Date: March 5, 2021
To: Zoning Committee of the Saint Paul Planning Commission
From: Mike Richardson, City Planner
Subject: Second Update on Zoning Case 21-225115, James and Lexington Apartments

ZONING COMMITTEE STAFF REPORT

FILE NAME: James Avenue Apartments

FILE #: 21-225-115

STAFF FINDINGS LOCATION DIAGRAM

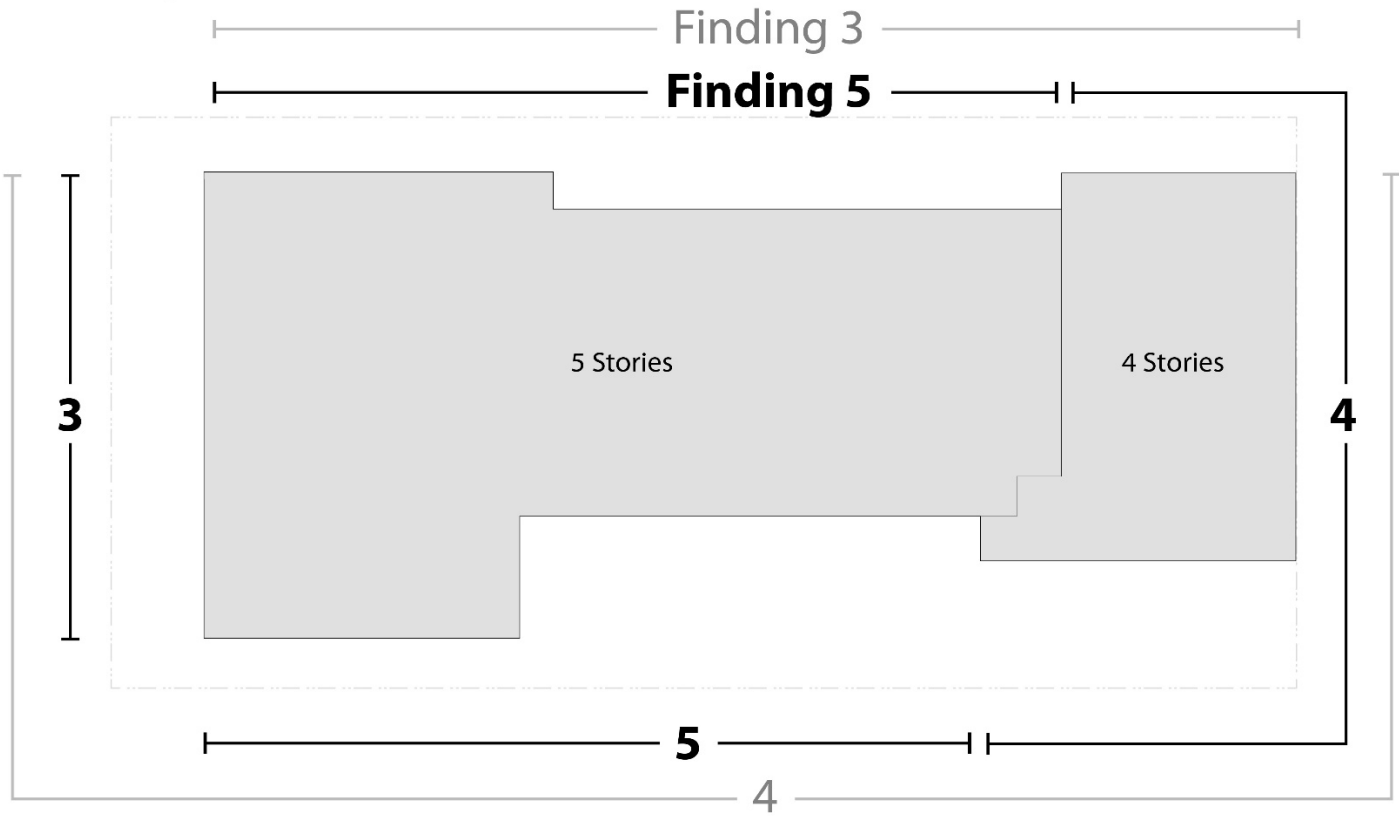
1. The Applicant agreed to reorient the building so that its front yard now faces Lexington Parkway instead of James Avenue. Reorientation will change the building's yard designations and therefore the required yard setbacks. A 25' minimum setback will now apply to the Lexington side of the building but the variance on the James side will be reduced.
2. The Applicant and staff worked to determine more precise height measurements, which reduced the height request and dependent side-yard setback requirements.
3. The Applicant has shifted the building to the eastern property line to increase the setback distance on Lexington Parkway.
4. Staff has revised its report and some recommendation based upon changes brought about by the building's reorientation, shift to the east, and updated measurements. See page 2 showing how findings are organized in the updated staff report.

VARIANCE REQUESTS

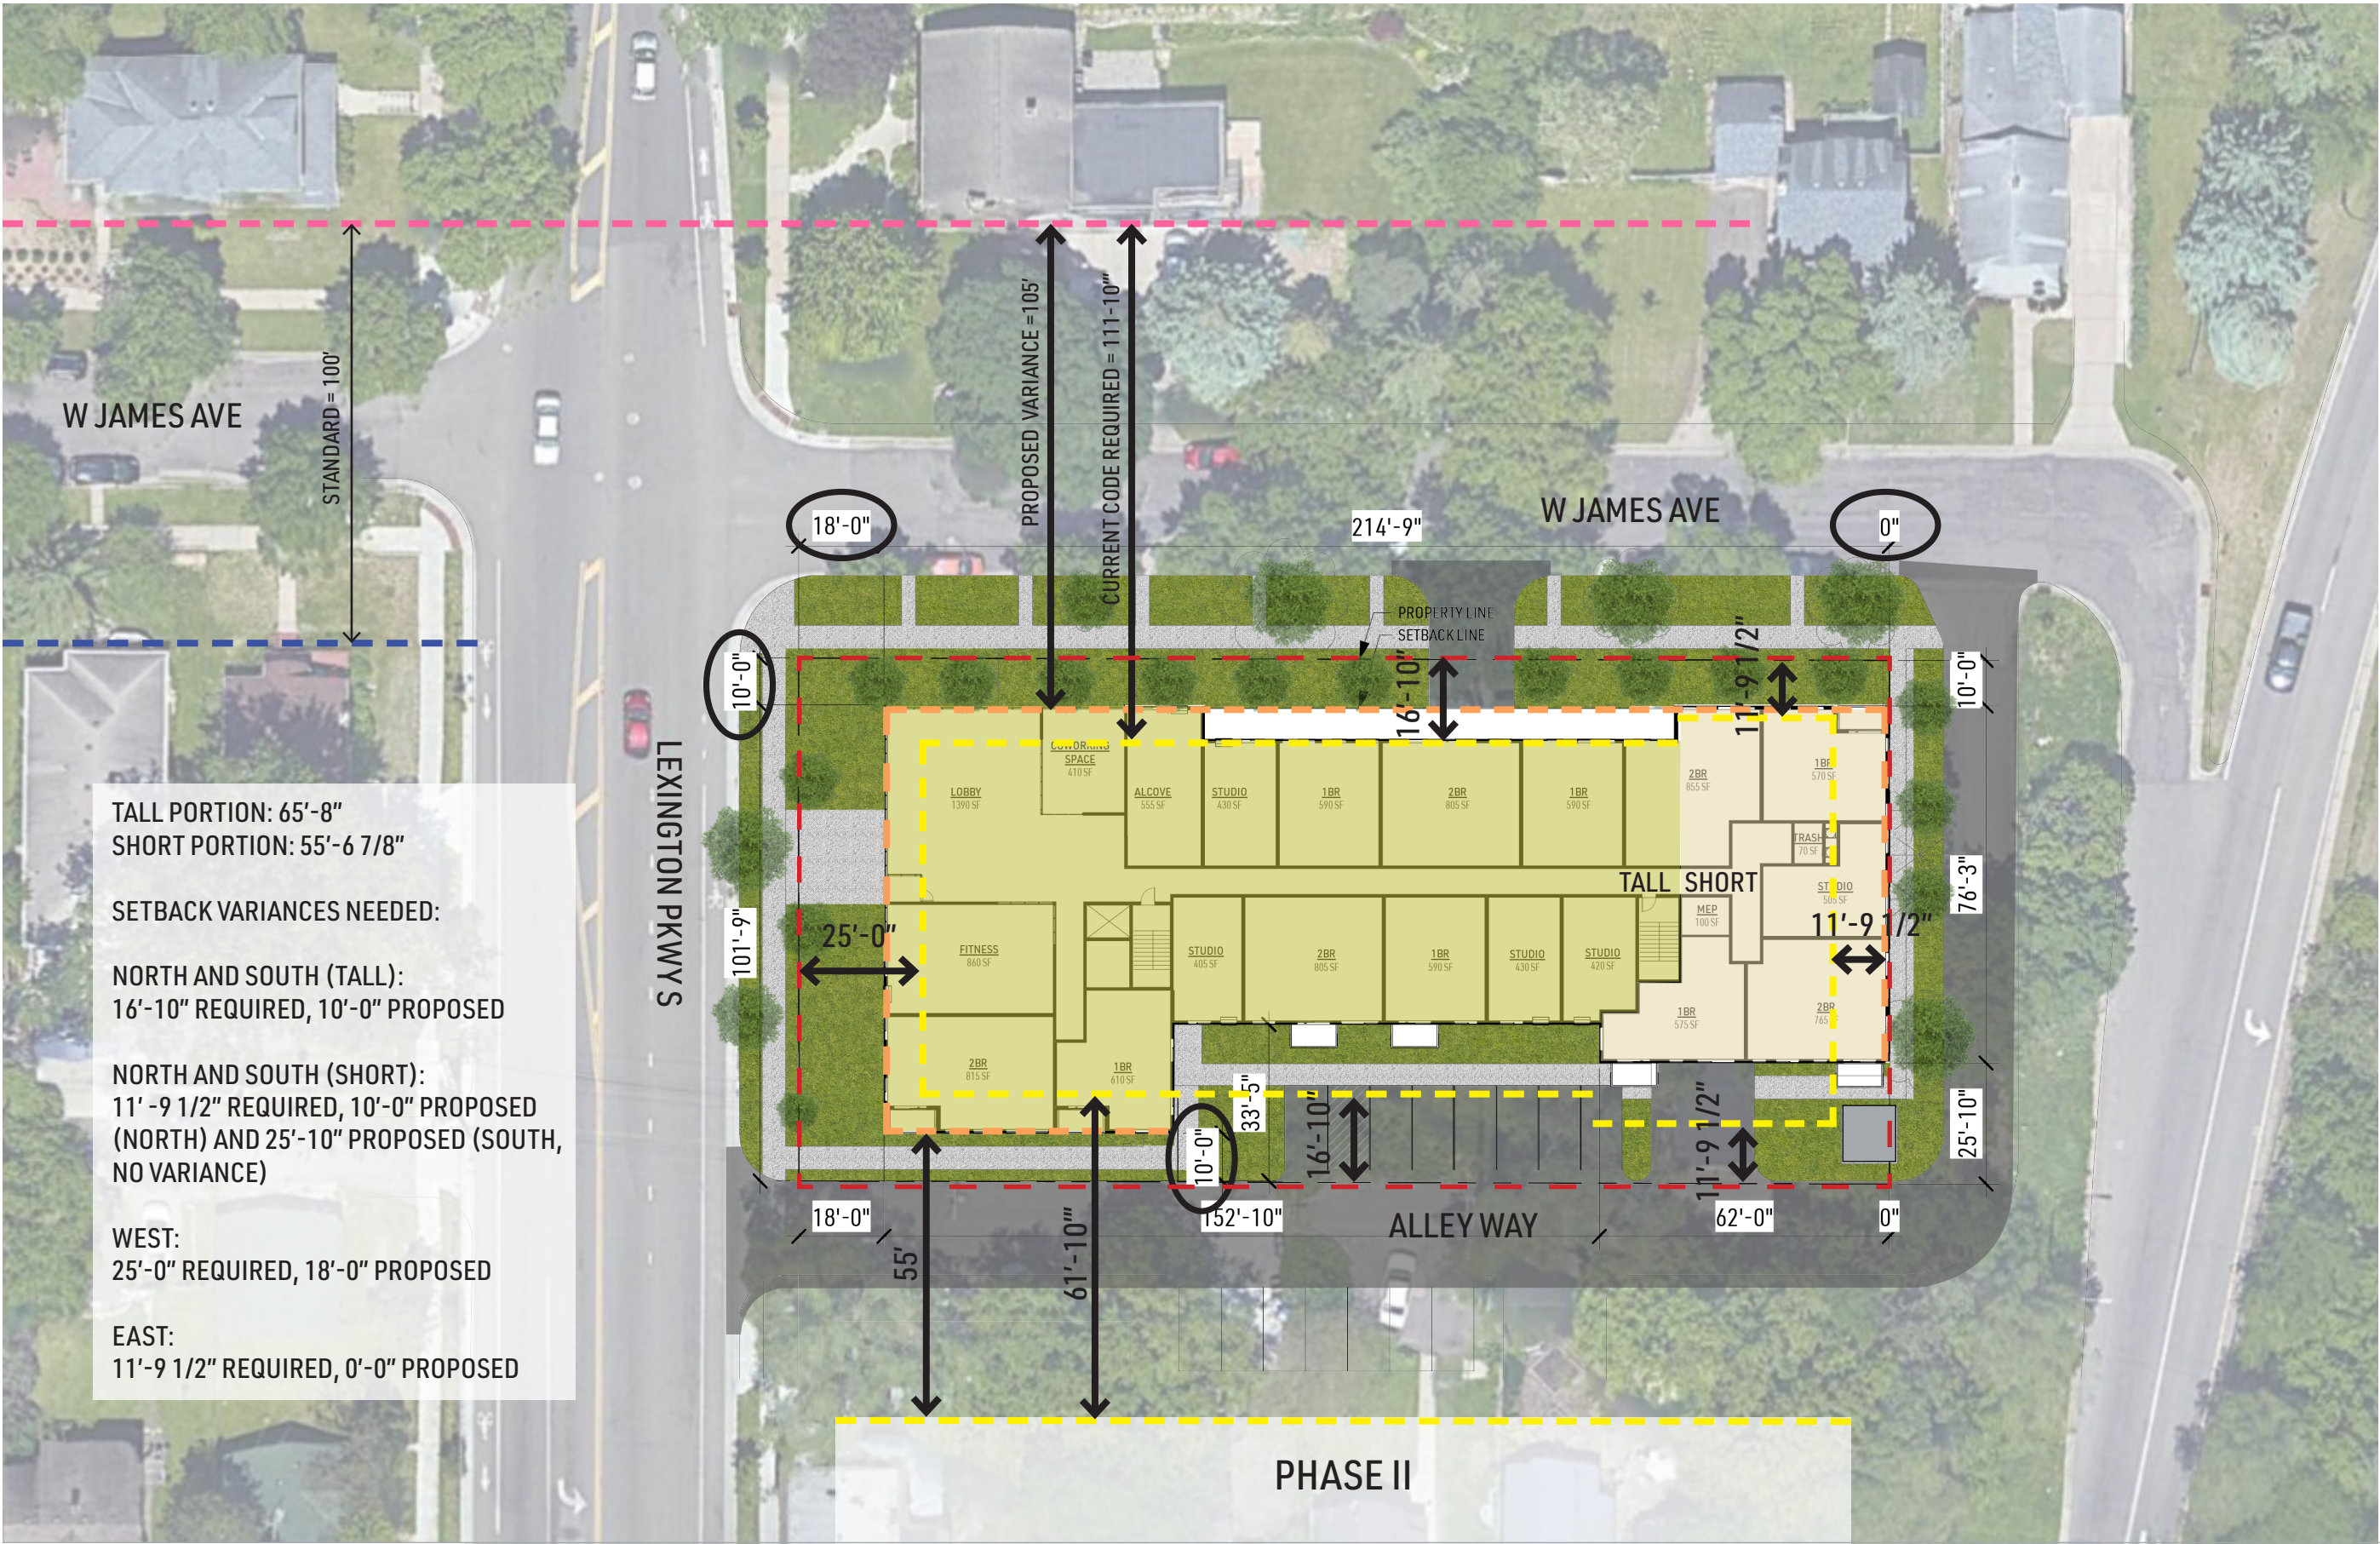
- ***The front of the building, which was previously James Avenue, would be revised to Lexington Avenue, which would require a twenty-five (25') setback from the Western property line.***
- ***The building would be (pushed) placed on the Eastern property line.***
- ***The average height of the building would be recalculated.***
- ***A new set of variances would be requested along with a revised CUP for height, see below.***

- ***North - 16'-10" required - 10'-0" proposed***
- ***South - 16'-10" required - 10'-0" proposed***
- ***East - 11'-9.5" required - 0'-0" proposed***
- ***West - 25'-0" required - 18'-0" proposed***

- ***Required height 50'-0" - 65'-8" proposed***

Maintaining legacy setbacks would allow the block to maintain its current spacing properties all the while all maximizing land usage and facilitating the ADA access from the street level to the main entrance of the building.
